25-61DA AJAX Site Improvements

Staff Report

ENGINEER'S NOTE

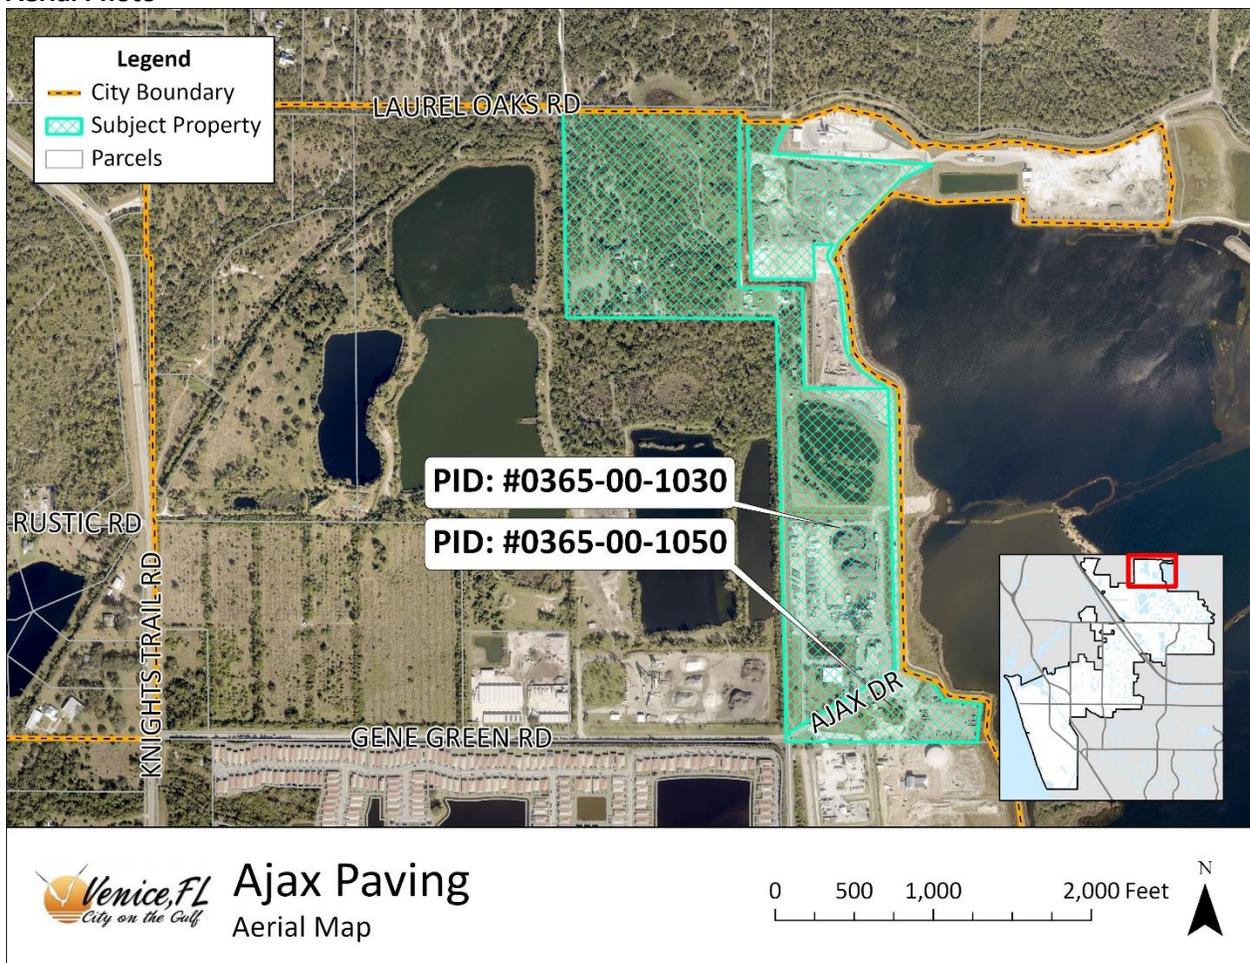
AFTER REVIEWING THE PLANNING AND ZONING DEPARTMENT COMMENTS ON THE LIGHTING PLANS, ITEM "4" REFERENCES CHAPTER 87, SECTION 3.9.3.A.8, WHICH ADDRESSES PARKING AREA LIGHTING AND PERMITTED POLE HEIGHTS.

DUE TO THE INDUSTRIAL NATURE OF THIS PARKING AREA, THE STANDARD LIGHT POLE HEIGHTS SPECIFIED IN THE CITY OF VENICE CODE (12-15 FEET) ARE INSUFFICIENT TO PROVIDE UNIFORM AND EFFECTIVE ILLUMINATION. THIS PARKING LOT IS INTENDED FOR CONSTRUCTION AND INDUSTRIAL TRUCKS, WHICH AVERAGE APPROXIMATELY 12 FEET IN HEIGHT. TO ENSURE ADEQUATE LIGHT DISTRIBUTION AND SAFETY, THE PROPOSED LIGHT POLE HEIGHTS EXCEED THE STANDARD RANGE.

THE PHOTOMETRIC ANALYSIS DEMONSTRATES THAT LIGHT SPILLAGE BEYOND THE PROPERTY BOUNDARIES REMAINS WITHIN ACCEPTABLE LIMITS. ALL FIXTURES LOCATED ALONG THE PARCEL PERIMETER WILL INCLUDE EXTERNAL GLARE SHIELDS TO PREVENT LIGHT TRESPASS ONTO ADJACENT PROPERTIES.

Summary Staff Comment: The proposed project is an industrial property and the requested Design Alternatives are to provide security for their parking area. The lighting will not exceed the maximum height for the parking area, which is 30', it will just not have a staggered height. While the lighting is taller at the perimeter it does not exceed the lighting levels at the property line.
